RE: LOWS 2111^R, Manzanita Drive, Descanso, APN 408-232-19, 23, and 24

This letter is written in response to the percolation test and septic system layout submitted to this department to serve a proposed 2 bedroom SFD on the above lot. There is a drainage swale at the west end of the lot, an easement running through the lot, and a vein of rock running west to east at the south end of the lot. Due to the limited available area on this lot, Gary Maxwell has proposed Horizontal Seepage Pits as the mechanism for sewage disposal. The most recent layout was field reviewed on January 27, 2004. Prior to further review, the following concerns need to be addressed:

RE: LOWS 2111, Manzanita Dr, Descanso, APN 408-232-19,23,24

**COUNTY OF SAN DIEGO
DEPARTMENT OF ENVIRONMENTAL HEALTH
PERCOLATION TEST REPORT**

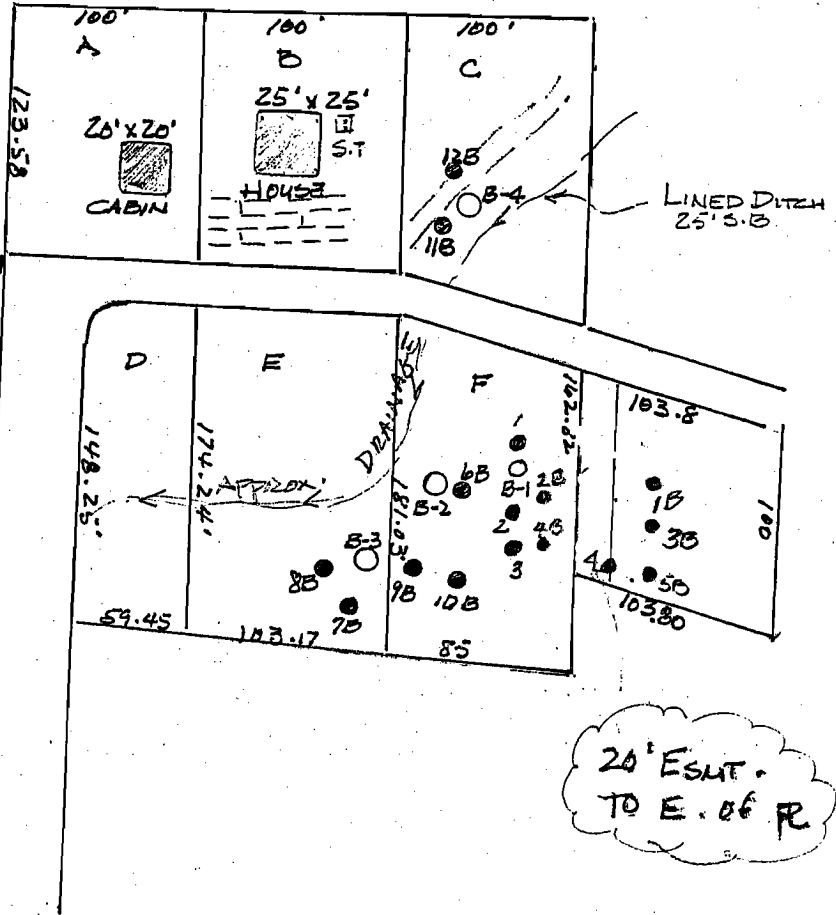
1. Per the original memo for this lot dated August 7, 2003, a historic high groundwater statement that states groundwater will not rise to within 10' of the bottom of the horizontal seepage pits needs to be submitted to this department. The statement is to be written by a registered professional.

2. Only 2 percolation test holes were completed at depths greater than 3'. Complete at least 4 additional test holes at depths throughout the proposed H-Pits. At least two of the holes are to be completed in the proposed reserve pit area.

3. Also per the original disapproval memo, the existing drainage swale has been plotted inaccurately on the layout. It is farther east on the lot than shown. As a point of reference, perc hole 6B is shown on the layout to be 50' from the centerline of the swale, but it is actually 30' from the centerline of the swale as measured in the field. Revise the layout to show the swale in the correct location, and a 50' setback to the swale.

4. The vein of rock running west to east appears to run into the reserve H-Pit area. I am requesting that both H-Pits be staked out on site, to ensure the reserve pit isn't in rock and that it meets proper setbacks to the 20' easement. Also, revise the layout to show the rock outcropping.

No borings were done in the reserve pit area. Due to the proximity of rock to the reserve pit, I am requesting that two backhoe slices be completed to 15' in the reserve pit area. One of the two slices is to be completed directly adjacent to the vein of rock.

5. Either the existing 20' easement needs to be vacated, or written permission needs to be obtained from SDG&E and the local water district to cross this easement with a sewage tightline.
6. The "ESMT FOR PCL C FOR H-PIT EXPANSION" is only 15' wide. It needs to be 26' wide. Revise the layout to show a 26' wide easement. Revise the dwelling so it meets proper

setbacks. Specify on the layout that the dwelling is to be built raised foundation.

7. Show a 25' setback to any water line easements, and provide a signed water line statement on the layout.
8. Prior to issuance of a septic permit, a certificate of compliance is to be completed that merges the parcels into one legal lot.

1. The layout shows groundwater at 10' in boring B-2, however the perc test states groundwater >20' in June/July 2002. Percolation test reports should always show the highest known water level, regardless of the date. Revise the perc test report to show depth to groundwater as 10'.

Provide a historic high groundwater statement from a licensed engineer or geologist that that groundwater will not rise to within 5' of the bottom of the leachlines and within 10' to the bottom of the H-Pits.

2. The existing drainage swale is not plotted accurately on the layout. It is farther east on the lot than shown. As a point of reference, perc hole 6B is shown on the layout to be 50' from the centerline of the swale, but it is actually 30' from the centerline of the swale as measured in the field. Revise the layout to show the swale in the correct location, and a 50' setback to the swale.

2. There's a vein of rock in the proposed leachfield, and it appears approximately 60' of leachline will be lost to rock. In addition, it may be difficult to tightline through the boulders on contour, resulting in additional lost leachfield area. If half the system is to be leachlines, revise the layout to show the areas of rock and don't show leachlines in the rock.

3. There are two issues that need to be addressed regarding the proposed H-Pit area in the center of the lot: 114' of pit length is shown, and 126' is needed. Also, one of the proposed pits appears to be in an easement. To pursue the pits for primary and reserve, the following needs to be done:

- a. Provide documentation that the easement has been vacated.
 - b. Show 128' of total lineal H-Pit area.

4. Prior to issuance of a septic permit, a "certificate of compliance" is to be provided that shows that the proposed lot is one legal lot.
5. Either revise the layout to show a pad or specify "house to be built raised-foundation" on the layout.
